Serial No. 01-638B  
NL&OS/ETS R0  
Docket No. 50-339  
License No. NPF-7

**VIRGINIA ELECTRIC AND POWER COMPANY**  
**NORTH ANNA POWER STATION UNIT 2**  
**ALTERNATIVE REPAIR TECHNIQUES-RELIEF REQUESTS NDE-048 and NDE-049**  
**REQUEST FOR ADDITIONAL INFORMATION**

**Response to NRC Request for Additional Information  
Relief Request NDE-048 and NDE-049  
North Anna Power Station Unit 2**

## **REQUEST TO USE EMBEDDED FLAW REPAIR TECHNIQUE NORTH ANNA POWER STATION UNIT 2 RELIEF REQUEST NDE-048**

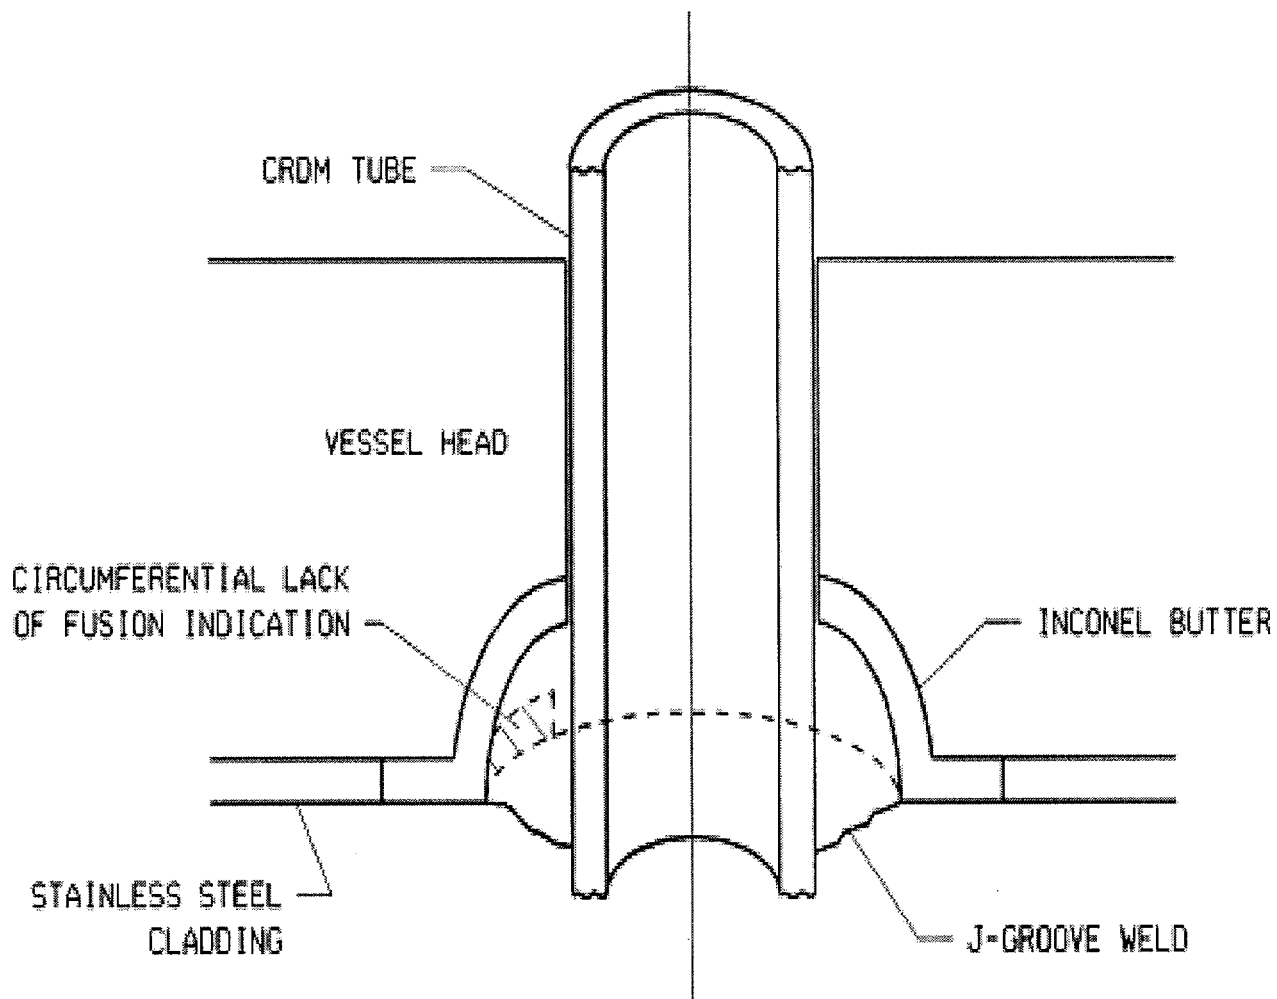
In Section V (page 4) of the submittal, there is a discussion on a postulated circumferential OD flaw in the J-groove weld. Provide a sketch of this crack configuration.

### **Response**
